Product/Process Change Notice

PCN # P-2004-0014

<p>PCN No.: P-2004-0014</p>	<p>Issue Date : 2020/11/13</p>
<p>Subject: Change of carrier tray spec. for 63BGA package</p>	
<p>Change Category: Carrier Tray Spec.</p>	
<p>Affected Products: All Macronix carrier trays with 63 BGA</p>	
<p>Reason of Change: To avoid the risk of IC being misplaced and jammed/damaged.</p>	
<p>Before Change :</p>	<p>After Change :</p>
<p>1) <u>Outline.(mm)</u> → Follow JEDEC' spec. (L*W*H) / (322.6x135.9x7.62)</p> <p>2). <u>Material:</u> → PPE Tray.</p> <p>3). <u>Matrix:</u> → X*Y : 22*10</p> <p>4). <u>Dimension:(mm) :</u> Please reference below illustration. 4-1). Pocket Pitch X value (eW): →12.80 +/-0.13 4-2). Pocket Pitch Y value (eL): →14.00 +/-0.13 4-3). Pocket center to tray edge X value (ZL): → 10.35 +/-0.13 4-4). Pocket center to tray edge Y value (ZW): →10.50 +/-0.13</p>  <p>5). <u>Pocket design</u> → IC positioning by pocket corner. (Top view of pocket)</p>  <p><u>No chamfering design.</u></p> <p>Pocket cross-section view</p>	<p>1). <u>Outline.(mm)</u> → No change.</p> <p>2). <u>Material:</u> → No change.</p> <p>3). <u>Matrix: :</u> → No change.</p> <p>4). <u>Dimension,(mm)</u> → No change.</p> <

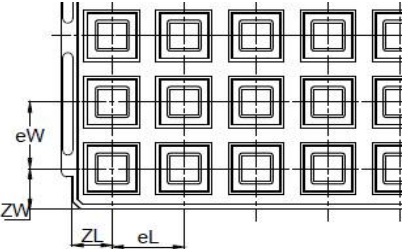
Based on past experience and experiment result, the new tray with a chamfering (sloped sidewall) design modification, can avoid the risk of the BGA being misplaced and be jammed/damaged by the other stacked tray due to the current steep sidewall design of the current tray. This advantage can assist the customer with a smoother operation at the SMT line.

Other than the pocket sidewall redesign, there is no change on the tray material, dimension, or matrix compared to the original tray design.
